Clause 169 Power System Parameter Adjustment

Michael Paul - ADI
Len Stencil - TDK
Felipe Jerez - TDK

Introduction

Type 0 Power Delivery

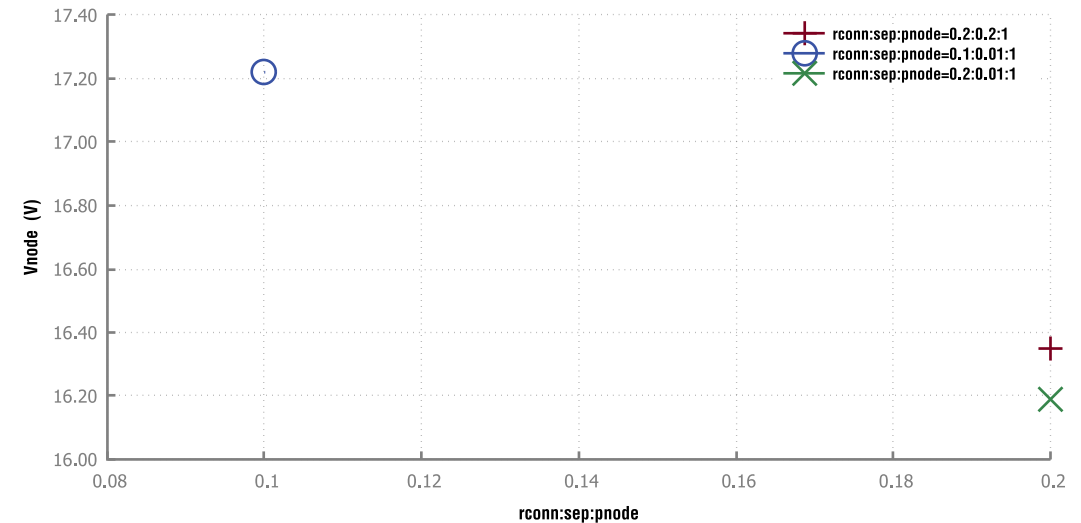
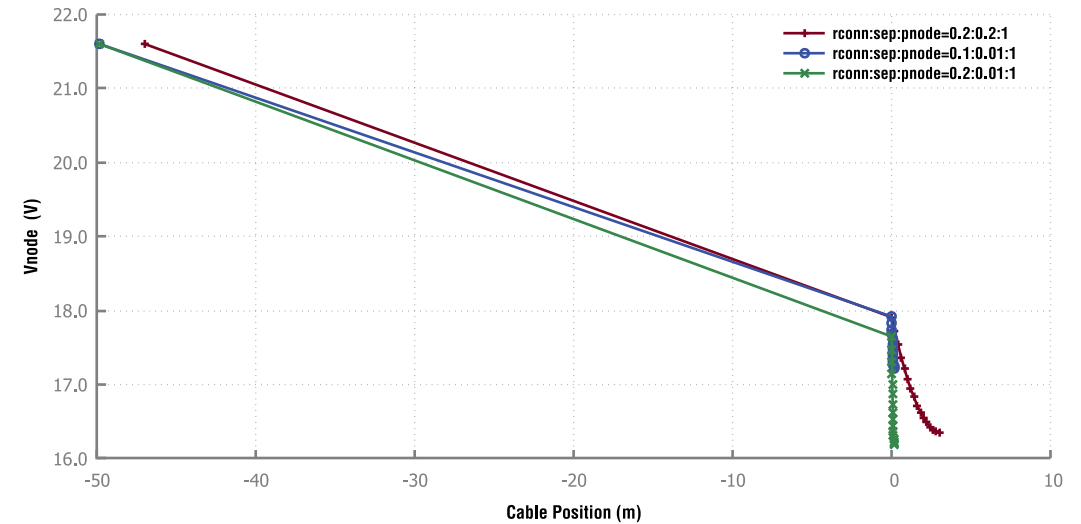
- Based around 24V (+/- 10%) supply
 - $V_{mpse_max} = 26.4V$
 - $V_{mpse_min} = 21.6V$
- Choose 20AWG Cable (50m @ 65C) ~4Ω
- Clump 16 nodes at the end of the mixing segment
- Last node must stay above 16V
- Deliver at least 1W per MPD

Option	Vpse	Ppse	Pmpd	Ploss	Ipse	Rchan	Vlast	rconn	sep	pnode
1	21.600	-20.456	16.000	-4.456	-0.947	7.129	16.354	0.2	0.20	1
2	21.600	-19.786	16.000	-3.786	-0.916	5.529	17.222	0.1	0.01	1
3	21.600	-20.698	16.000	-4.698	-0.958	7.129	16.188	0.2	0.01	1

- All options work well
- We can deliver 16 MPDs 1W each @ 50 meters

Type 0 Unit loads – Maximize Power

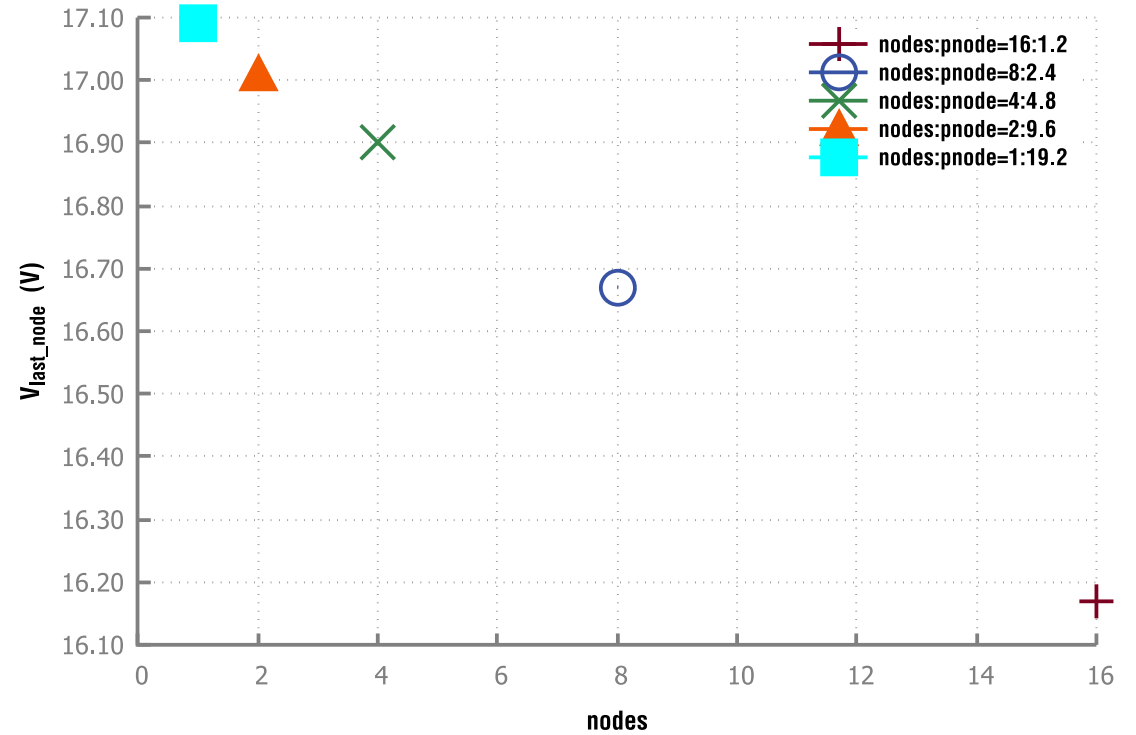
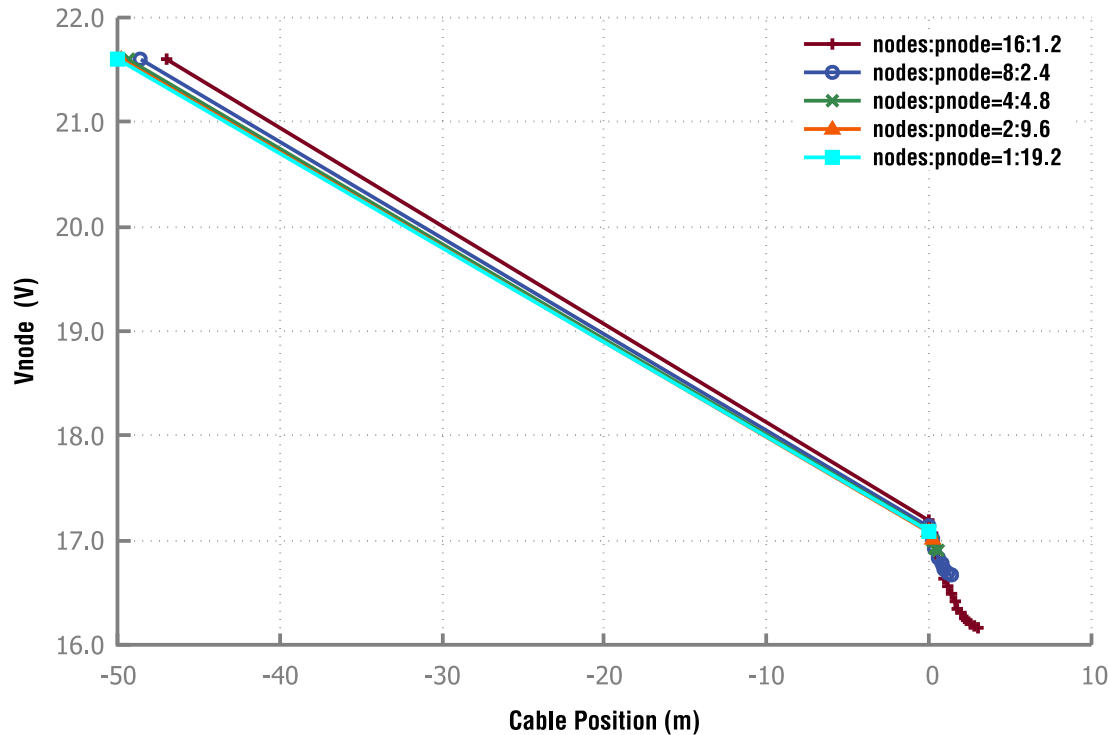
Nodes x Load	Vpse	Ppse	Pmpd	Ploss	Ipse	Rchan	Vlast	Ilast	nodes	pnode
16 x 1u	21.600	-25.089	19.200	-5.889	-1.162	5.529	16.174	0.074	16	1.2
8 x 2u	21.600	-24.627	19.200	-5.427	-1.140	4.729	16.667	0.144	8	2.4
4 x 4u	21.600	-24.420	19.200	-5.220	-1.131	4.329	16.901	0.284	4	4.8
2 x 8u	21.600	-24.329	19.200	-5.129	-1.126	4.129	17.014	0.564	2	9.6
1 x 16u	21.600	-24.265	19.200	-5.065	-1.123	4.014	17.091	1.123	1	19.2

Optimizing Type 1 Power Delivery

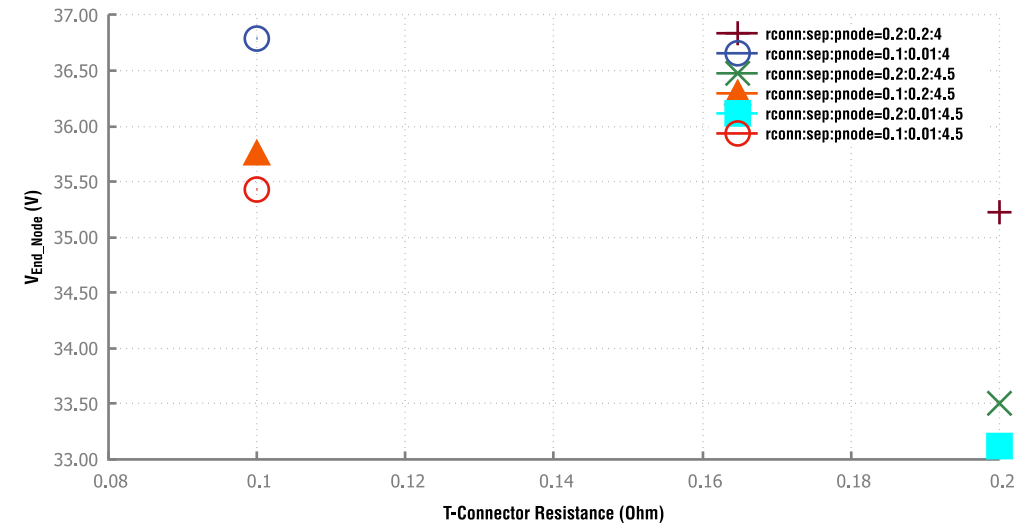
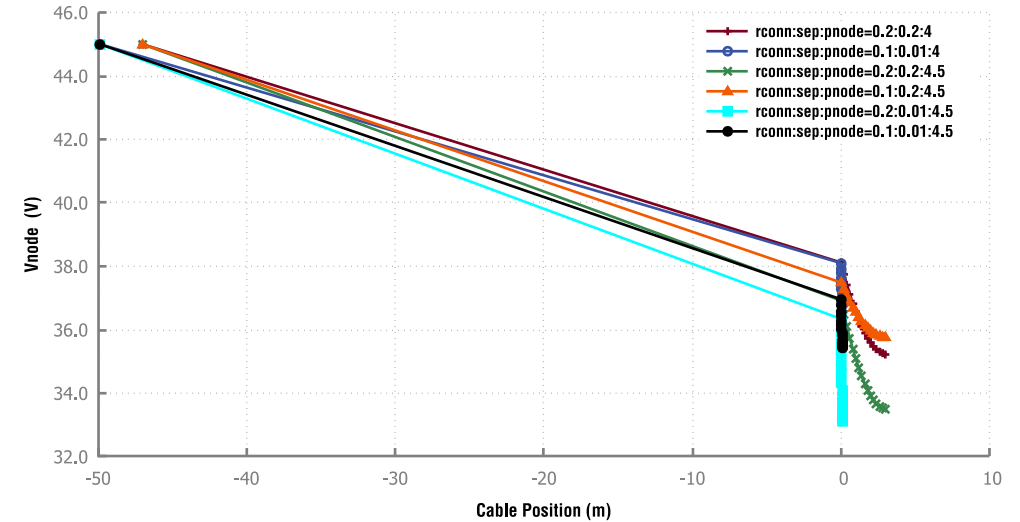
Option	Vpse	Ppse	Pmpd	Ploss	Ipsc	Rchan	Vlast	rconn	sep	pnode
1	45.000	-79.491	64.000	-15.491	-1.766	7.129	35.221	0.2	0.20	4
2	45.000	-77.317	64.000	-13.317	-1.718	5.529	36.790	0.1	0.01	4
3	45.000	-93.422	72.000	-21.422	-2.076	7.129	33.496	0.2	0.20	4.5
4	45.000	-89.104	72.000	-17.104	-1.980	5.529	35.754	0.1	0.20	4.5
5	45.000	-94.639	72.000	-22.639	-2.103	7.129	33.118	0.2	0.01	4.5
6	45.000	-90.082	72.000	-18.082	-2.002	5.529	35.432	0.1	0.01	4.5

- ❌ Options 1 and 2 are only delivering 64W total
- ❌ Options 3 and 5 deliver 72W, nominal PSE output is > 90W
- ✅ Options 4 and 6 deliver 72W with PSE output <= 90W
Requires <= 100mΩ connector resistance per node

Type 1 Unit loads – Maximize Power

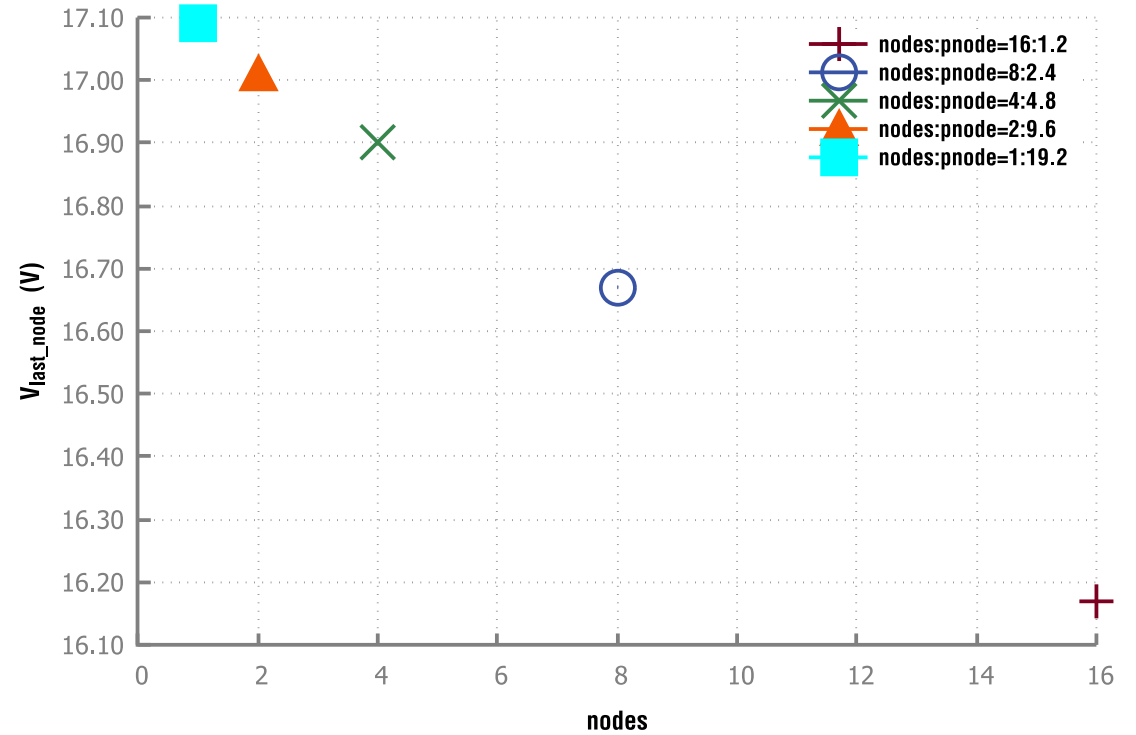
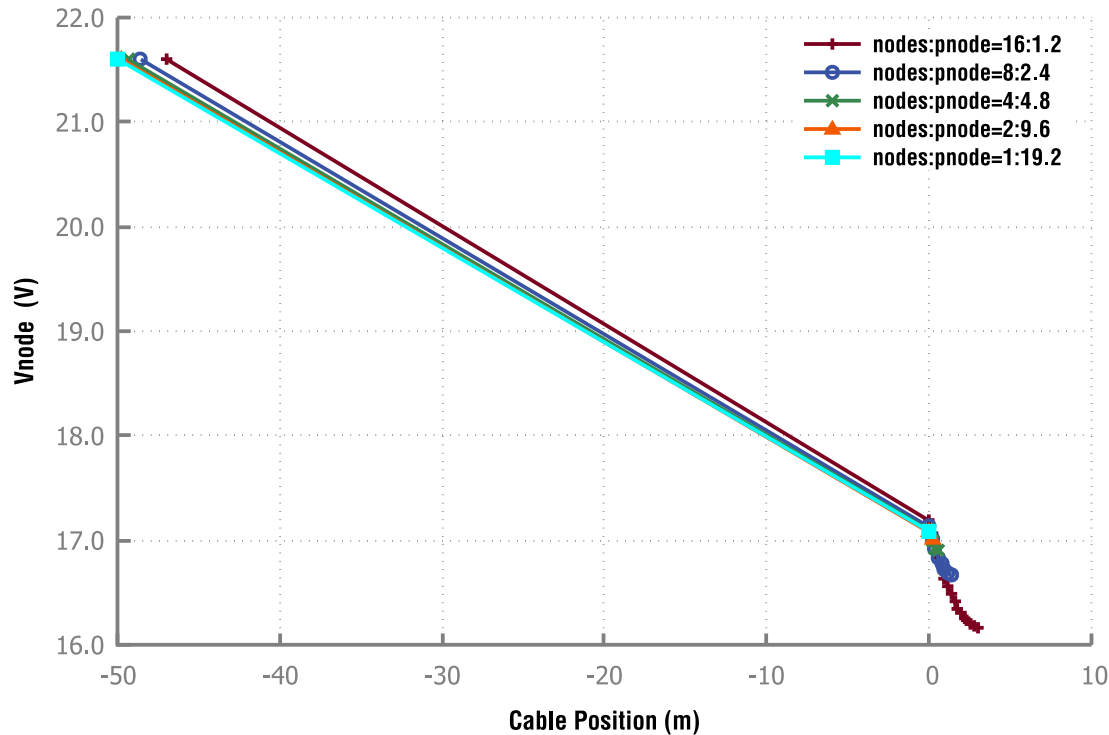
Nodes x Load	Vpse	Ppse	Pmpd	Ploss	Ipsc	Rchan	Vlast	Ilast	nodes	pnode
16 x 1u	45.000	-89.104	72.000	-17.104	-1.980	5.529	35.754	0.126	16	4.5
8 x 2u	45.000	-87.944	72.000	-15.944	-1.954	4.729	36.545	0.246	8	9.0
4 x 4u	45.000	-87.409	72.000	-15.409	-1.942	4.329	36.927	0.487	4	18
2 x 8u	45.000	-87.170	72.000	-15.170	-1.937	4.129	37.113	0.970	2	36
1 x 16u	45.000	-87.003	72.000	-15.003	-1.933	4.014	37.240	1.933	1	72
